**LEXINGTON-FAYETTE URBAN COUNTY GOVERNMENT
CONTRACT CHANGE ORDER**

Date:	June 30, 2017
Project:	Black & Williams Center Roof Replacement & Repairs
Location:	498 Georgetown St
Contract No.	054-2017
Original Contract Amt.	\$207,890.00
Cumulative Amount of Previous Change Orders	\$17,359.00
Percent Change - Previous Change Orders	8.35%
Total Contract Amount Prior to this Change Order	\$225,249.00
Change Order No.	2

PROJECT: Black & Williams Center Roof Replacement & Repairs

CHANGE ORDER #: 2

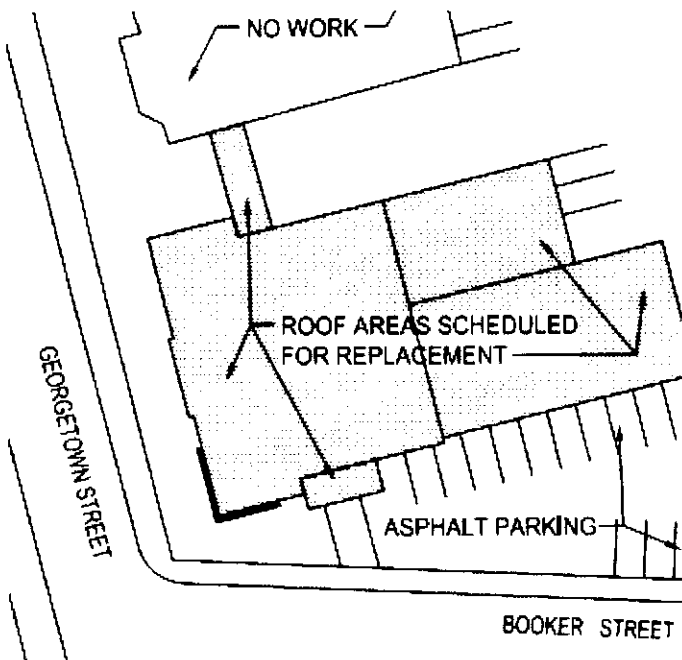
I have identified the areas, as I understand if from Greg's message, on the key plan below.

This request is for the southwest corner of the building. The area is from the southwest corner along the front wall approximately 25 feet. It goes from the coping to the second floor window lintel. The second wall is from the southwest corner along the side wall at Booker Street approximately 20 feet. This area is from the coping down approximately twelve courses of brick including the stone belt course.

The side wall coping has bowed outward approximately 1.5" and the brick another .5" past that. On the front wall, the coping has remained straight but the brick have moved outward approximately 2". An examination of the parapet wall shows the original mortar has deteriorated severely and has no strength remaining. The sections we have already repaired were so damaged that the mortar was little more than dust, no bond remained. The parapet was repointed in the past but it was shallow and only serves to prevent the deteriorated mortar from being eroded from the wall. This section has moved and is likely to fall in the future. The remainder of the parapet mortar is similar but the brick have not moved as significantly as this section.

The Roofing portion of this project will include the removal and reinstallation of the flashing in the estimated 45' area of repair.
